Alcorn St
140 Alcorn St,
Byron Bay, NSW 2481

012832
Site Plan
1:200 @ A3
05/08/22

Project Number
Drawing Name
Scale
Date
012832
Elevations
1:200 @ A3
05/08/22

Drawing Number
Revision
DA300
G

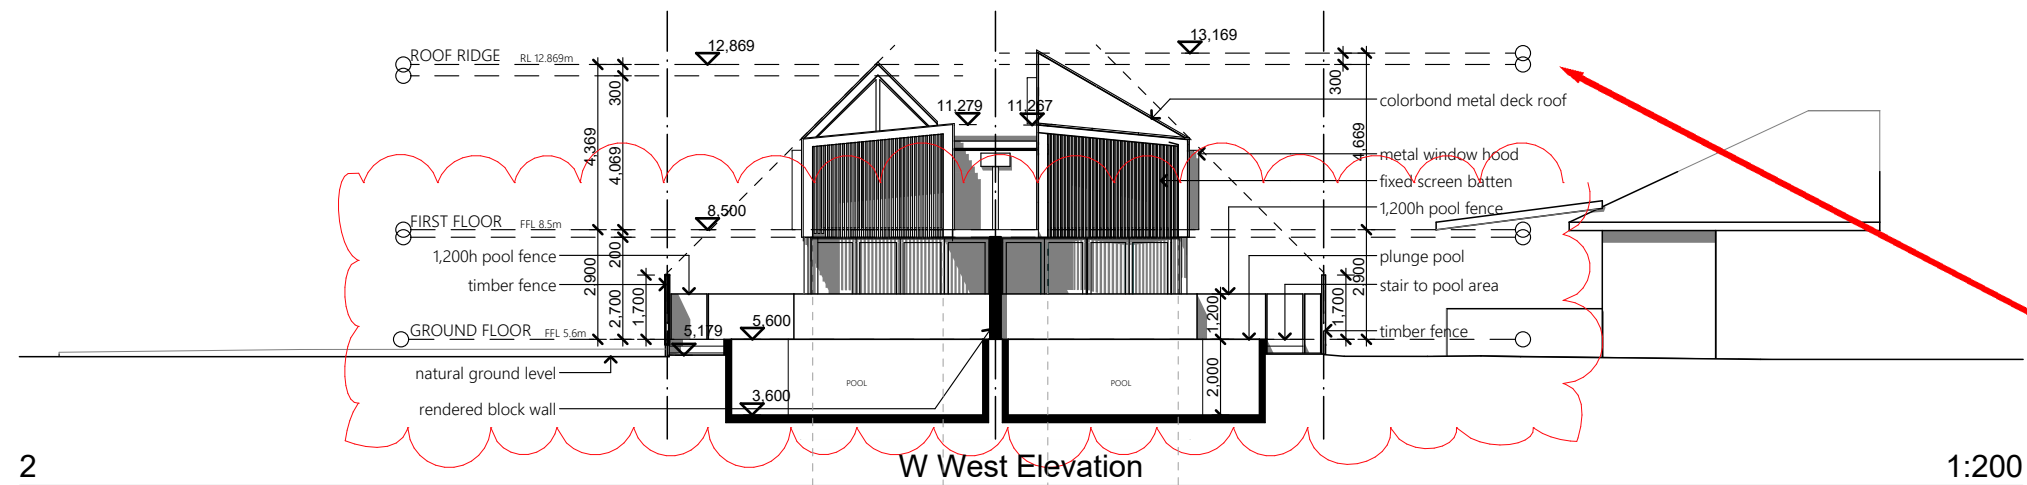
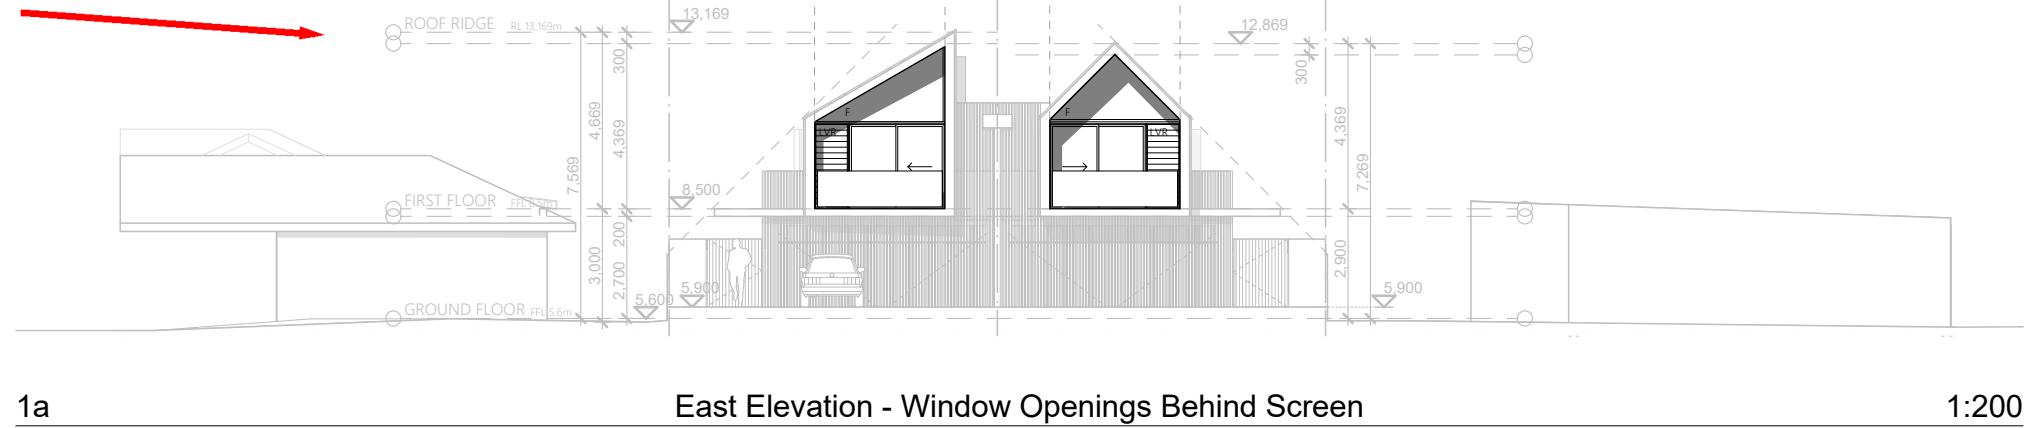
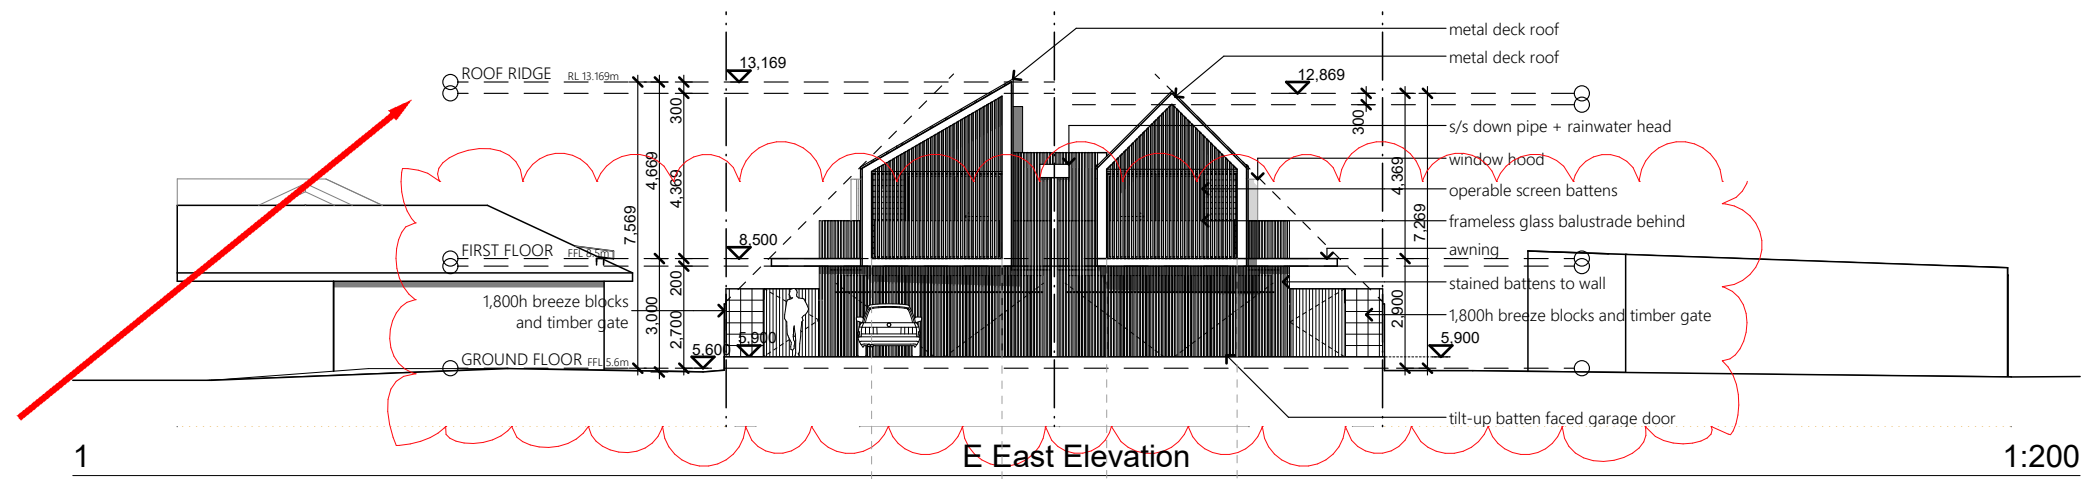
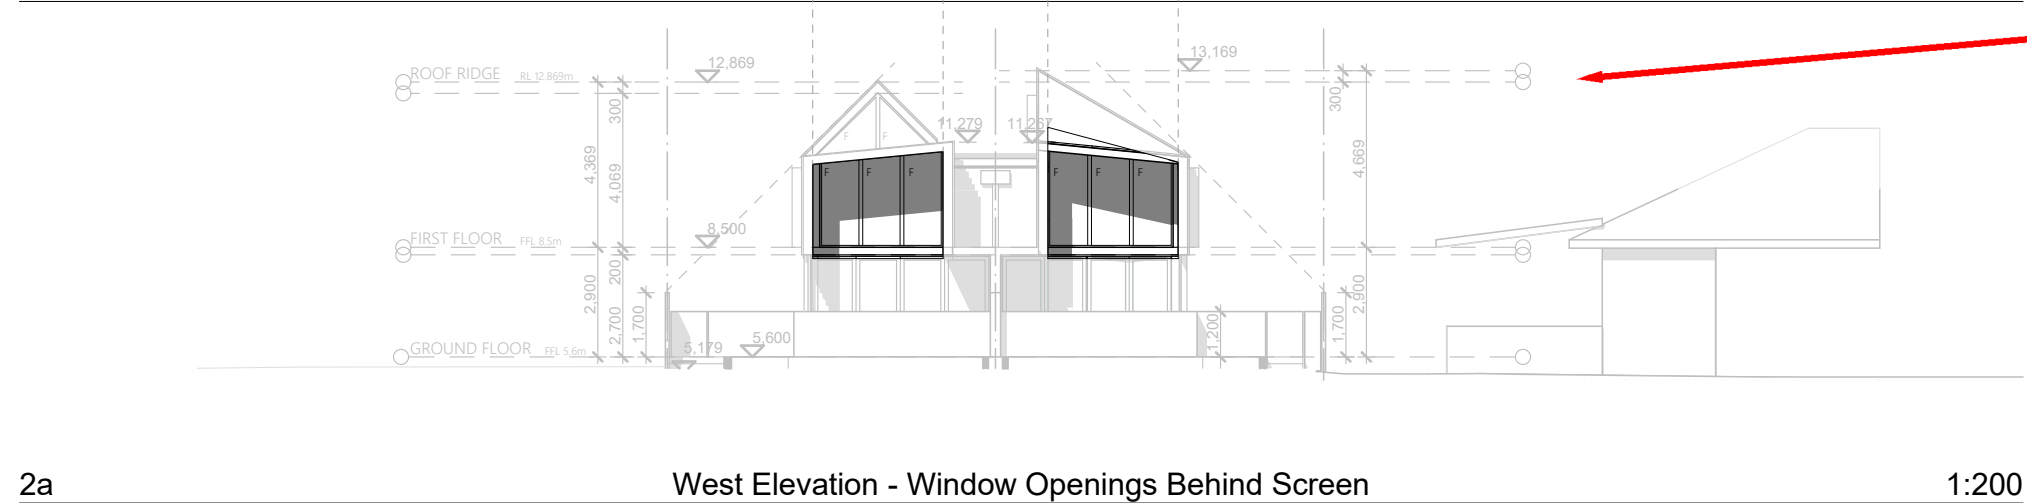
Roof ridge height to be lowered - see condition 7

Roof ridge height to be lowered - see condition 7
